PLANNING COMMISSION PLANNING COMMISSION-SPECIAL MEETING 2022-05 Wednesday, July 13, 2022, at 6:00 PM

AGENDA ITEM	SUBMITTED BY	PRESENTED BY
Special Use Review - 121 W 2nd Ave	Abdul Barzak, Town Planner	Abdul Barzak, Town Planner
ACTION REQUESTED		
Community Development and Management ask that the Planning Commission review, discuss, and approve Resolution PC-2022-01R and forward a recommendation to the Town Council on the Special Use Review at 121 W. 2nd Avenue. Actions that may be taken: 1. Approve PC-2022-01R and forward a recommendation of approval of the special use review application for 121 W 2nd Ave to Town Council, subject to the conditions listed therein. 2. Take No Action.		<u>Report</u> <u>Action Requested</u>
BRIEF SUMMARY		
The owner of 121 W. 2nd Avenue is asking for a Special Use Review to construct a personal shop on this lot. The shop is a 36 foot by 80 foot metal building that will be used as personal work and office space. The proposed building will not have water or sewer at this time. The building as proposed violates the Land Use Code side setback requirement of 7.5'. The applicant is requesting a variance for both side setbacks to be at 6.9' to be contemplate

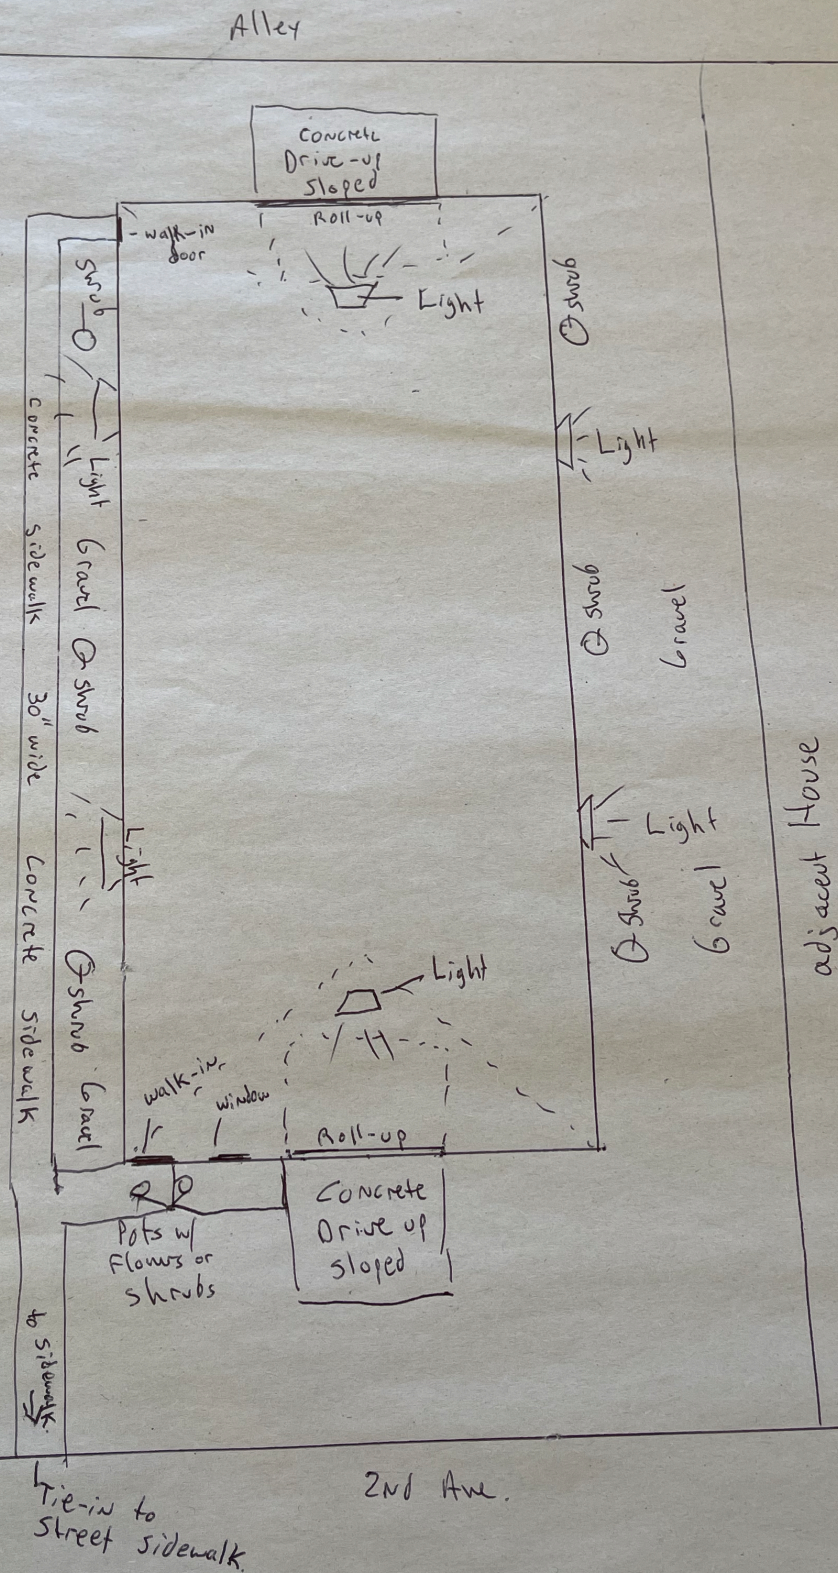
1.) Not shown.
Awning over Front
Walk-in door and
window.

SITE PLAN
121 2ND AVENUE
LOT 5 & 6 BLOCK 3
TOWN OF SEVERANCE
WELD COUNTY, COLORADO

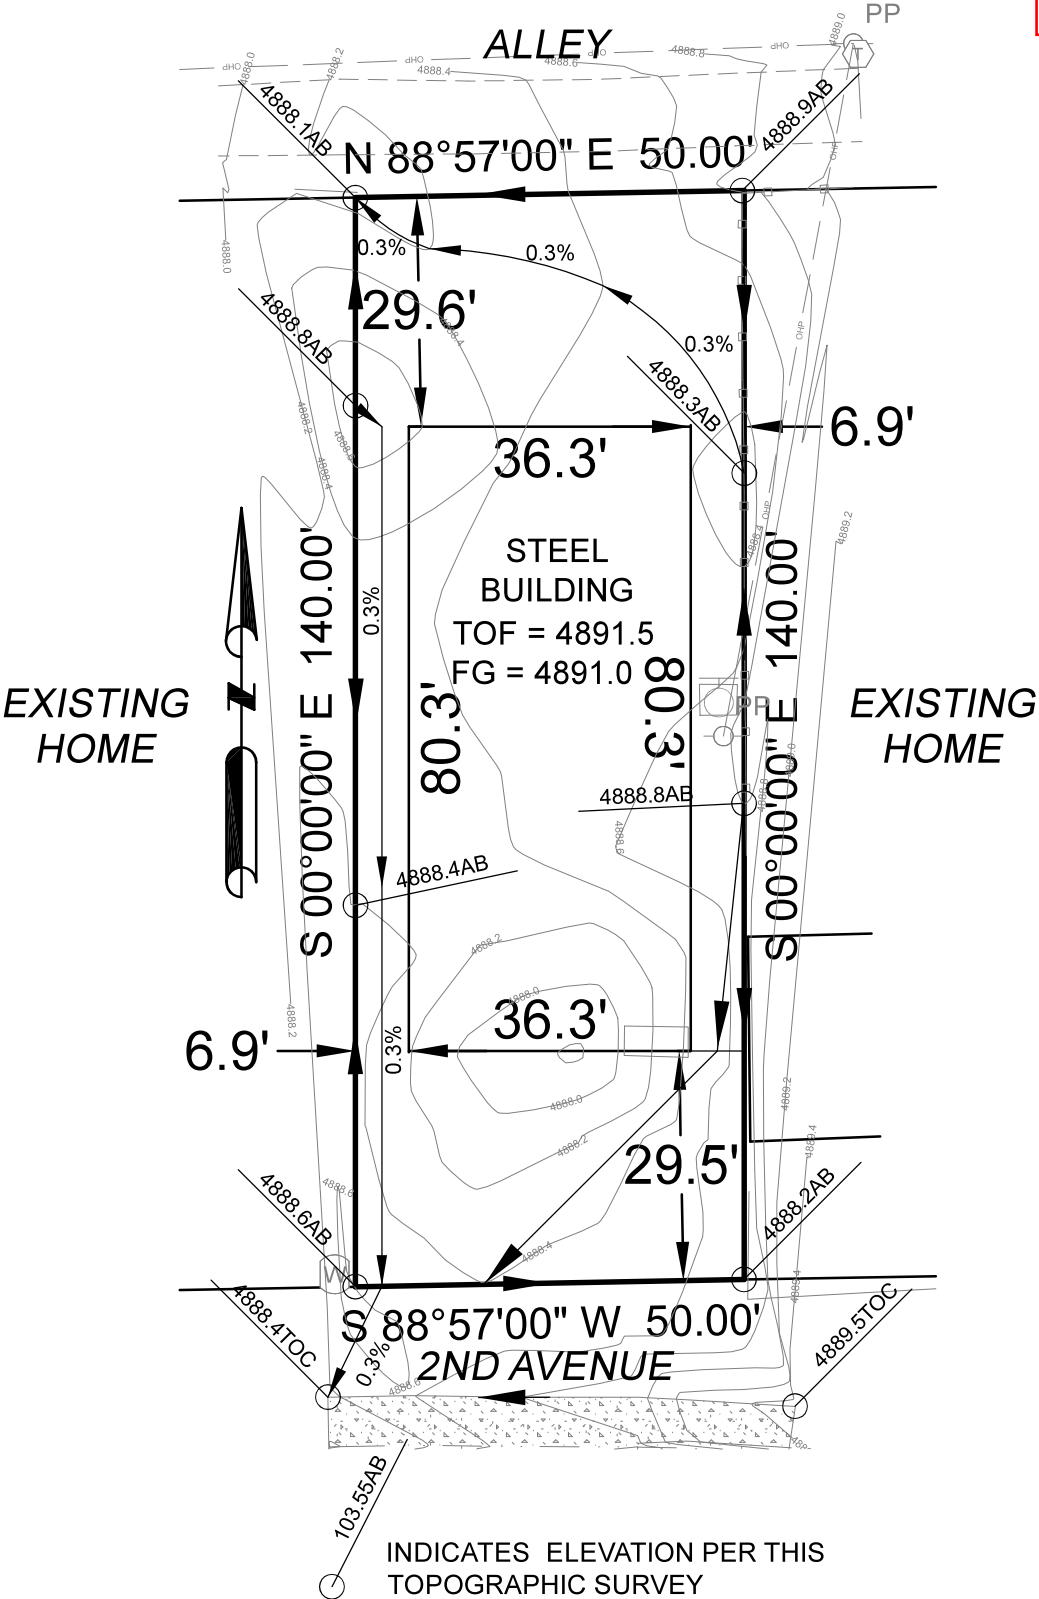
TOWN OF SEVERANCE
DEVELOPMENT REVIEW
Submittal Type: Modified Site Plan
Submittal No: 5
Project Name: 121 W. 2nd Avenue
Project No: 0042.0021.00
Reviewed By: AKM/CEM
Review Date: May 11, 2022

No Comments

BERMS MAY BE REQUIRED WITH THE
DRAINAGE SWALE(S) TO KEEP
STORMWATER ON THE SUBJECT
PROPERTY AND TO PROVIDE
DRAINAGE TO ALLY AND 2ND AVENUE
